12-45 Log #738 NEC-P12
(670.3(A))

Comment on Proposal No: 12-82

Figure 725.154
Cable
Substitution
Hierarchy

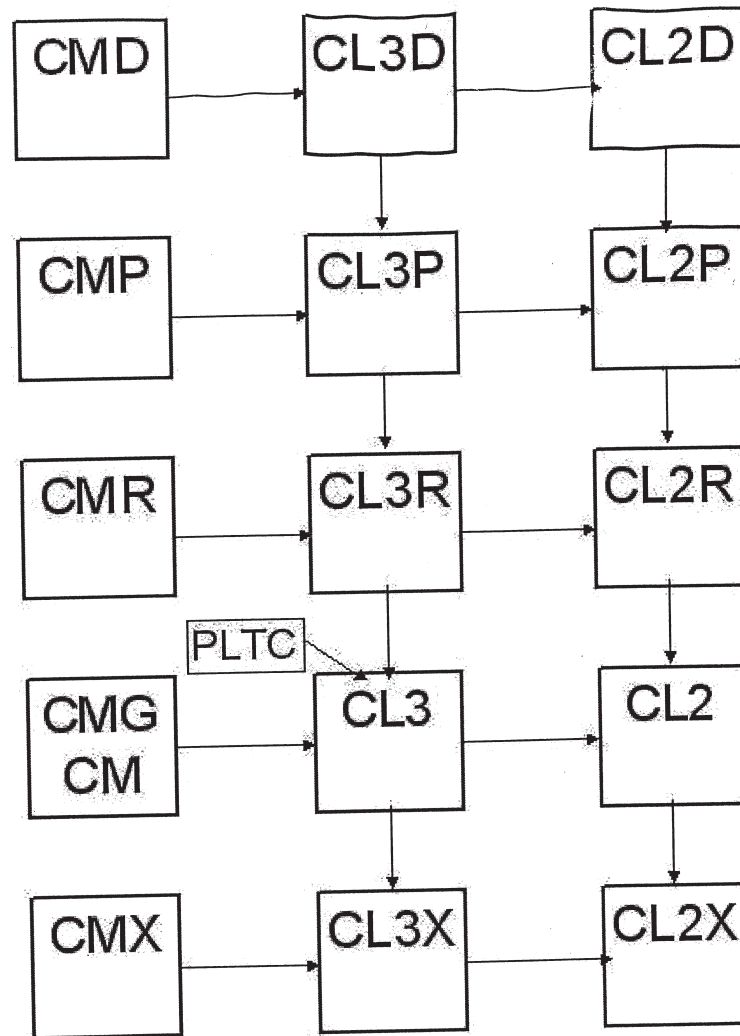
Comment 3-205 (Log #3681)

Type CM—Communications wires and cables.
Type CL2 and CL3—Class 2 and Class 3 remote-control, signaling, and power-limited cables.
Type PLTC—Power-limited tray cable.
[A]→[B] Cable A shall be permitted to be used in place of cable B.
